Design Revisions / Additional Details Information:

Rear elevation

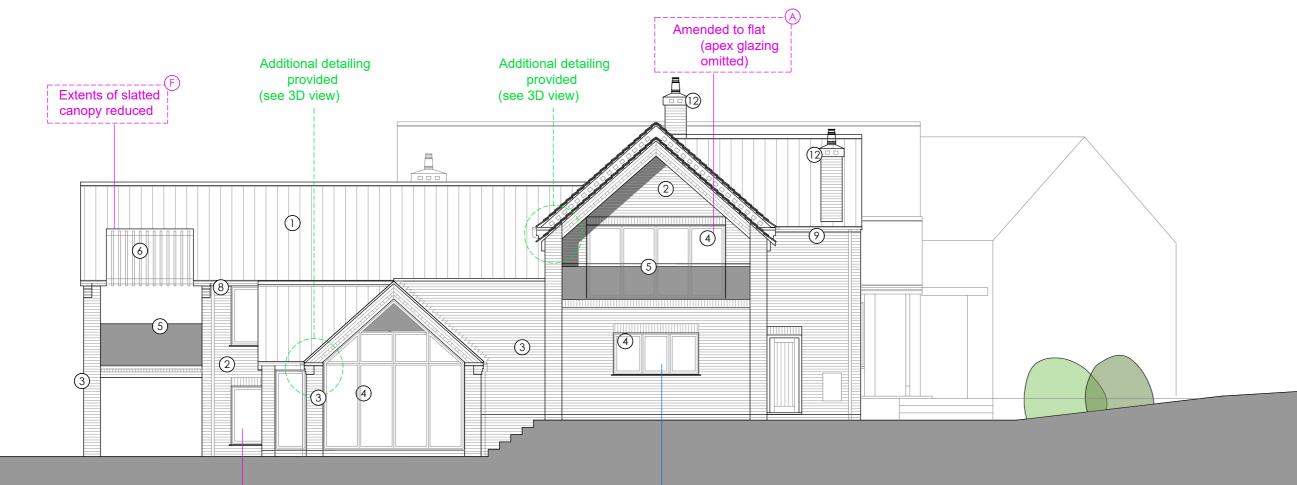
- A as noted 2 large apex glazed windows changed to flat head to avoid works in loft area rooms no longer to have vaulted ceiling.
- B as noted 3 sections of open slatted roof extents to be reduced.

- C/D Sunroom glazing extent to be reduced window amended and brick panel increased
- E as noted 2 existing side windows in lower ground games room to be retained / sizes amended.

- F front elevation to include open slatted roof section to match rear elevation slatted opening.
- G as noted to 3 no front gables brick banding to be omitted with newly supplied brick match - due to varying building level a consistent band could not be achieved. (note feature brick detail window surrounds to be retained)

- H/I n/a
- J Front elevation single kitchen window increased to triple casement to match updated front gables
- K as noted 3 feature gables original 2 separate independent windows to be replaced with a central triple casement window.

- L Front elevation porch design revised brick porch with canopy and brick detailing to match (to replaced
- previously proposed oak porch which was not consistent with the brick detailing throughout)

- M Glazing widened to 4 panes
